Access Compliance Report

Public Rights-of-Way

Intersection ID: N/A	Main Street: STONEWALL_ST	Cross Street: JOHN_BELK_RA	Location: S
ADA ID: FB095A8D2CBC	Ramp Type: Directional1	Initial Pass/Fail: Pass	Overall Compliance: No
Severity Score: 0			
Codes/Mitigation Info/Possible Solution		Field Measurements/Component Compliance

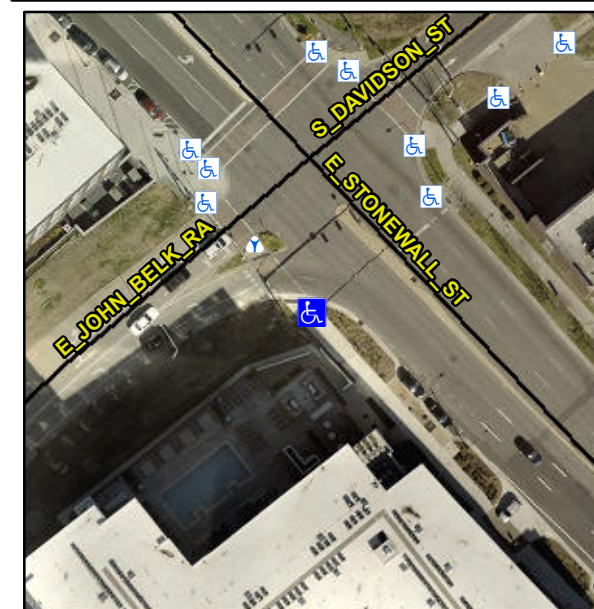
**R304.2.2-Perp, R304.3.2-Para,
R304.5.3**

Compliance	Description	Data	Compliance	Description	Data
N/A	Ramp Length (in)	400.0	Yes	Grade Break?	Yes
Yes	Ramp Width (in)	118.5	No	Grade Break Slope (%)	8.8
Yes	Ramp Slope (%)	6.8	No	Grade Break XSlope (%)	6.3
Yes	Ramp XSlope (%)	0.7			
Yes	Flare Type LT	N/A	Yes	Flare Type RT	N/A
N/A	Flare Slope LT (%)	N/A	N/A	Flare Slope RT (%)	N/A
N/A	Flare Traversable LT?	No	N/A	Flare Traversable RT?	No
Yes	Landing Length (in)	48.0	Yes	DWS Provided?	Yes
Yes	Landing Width (in)	118.5	Yes	DWS Contrast?	Yes
No	Landing Slope (%)	2.2	Yes	DWS Length (in)	24.0
Yes	Landing X Slope (%)	1.1	Yes	DWS Full Width?	Yes
N/A	Landing Curb? (Y/N)	N/A	Yes	DWS Offset LT (in)	2.0
N/A	Shared Landing?	No	Yes	DWS Offset RT (in)	2.0
Yes	Gutter Ponding?	No	Yes	Gutter Slope (%)	2.3
Yes	Gutter Lip Ht (in)	0.0	No	Gutter X Slope (%)	5.1
N/A	Painted X Walk1?	Yes		Road Slope (%)	3.4
	X Walk 1 Direction	To NW		Road X Slope (%)	2.4
	X Walk 1 Width (in)	125.0		Clear Space?	Yes

**Remove & Replace Entire Ramp.
Remove & Replace Gutter.**
